Informal Document No. GRRF-65-07
(65th GRRF, 2 - 6 February 2009,
agenda item 6.)

REGULATION No. 90
(Replacement brake linings)

Proposal for draft amendments to Regulation No. 90

Submitted by the GRRF Informal Group on "ECE-R.90 - Replacement Discs and Drums"
(RD&D) */

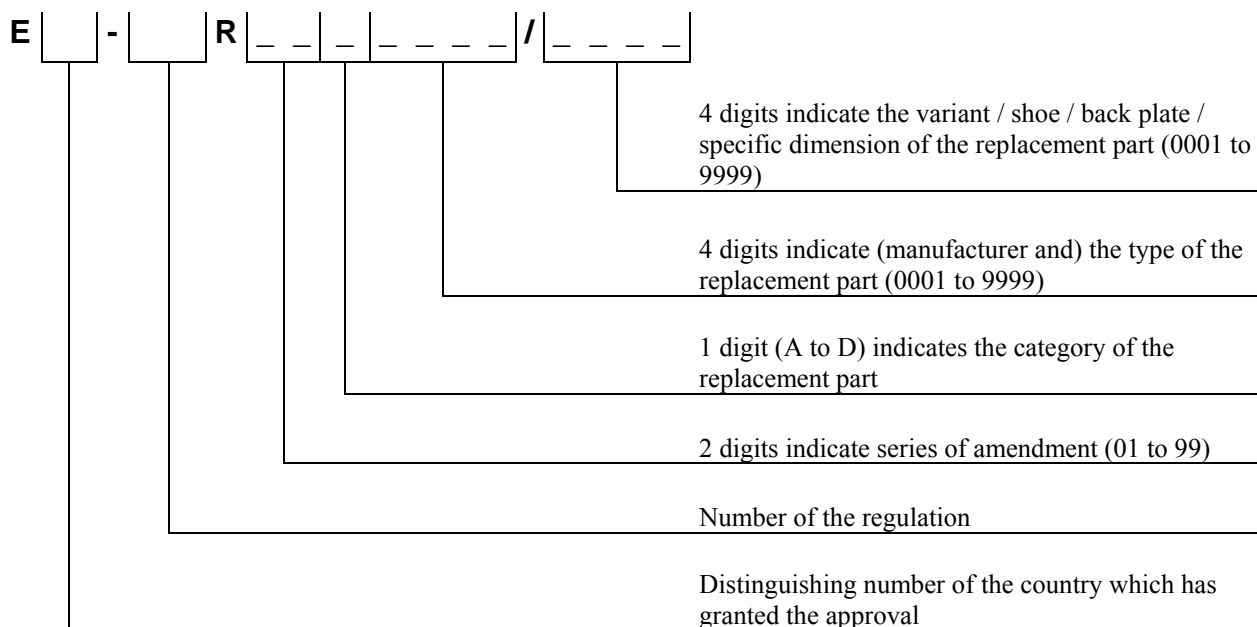
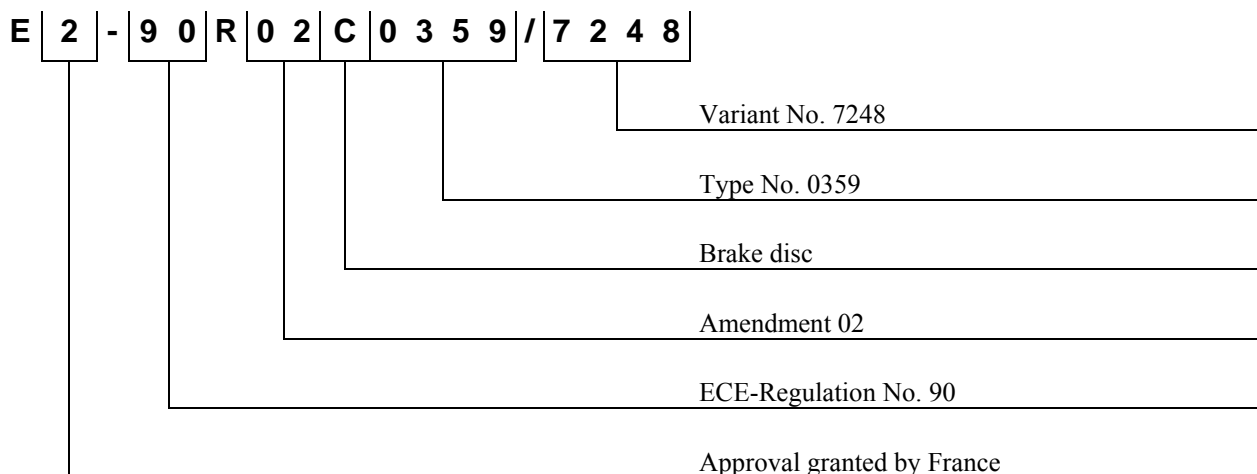
- “4.2. To each replacement part approved there shall be assigned an approval number comprising four groups of digits:
- 4.2.1. The first two digits (at present 02 for the Regulation in its 02 series of amendments) shall indicate the series of amendments incorporating the most recent major technical amendments made to the Regulation at the time of issue of the approval.
 - 4.2.2. The following single digit shall indicate the category of the replacement part as follows:
 - A Replacement brake lining assembly
 - B Replacement drum brake lining
 - C Replacement brake disc
 - D Replacement brake drum

4.2.3. The next four digits shall indicate the manufacture and the type of the brake lining, the type of disc or the type of drum.

A suffix of four digits shall indicate

- the shoe or back plate or specific dimension in the case of drum brake linings,
- the variant in the case of a replacement disc or replacement drum
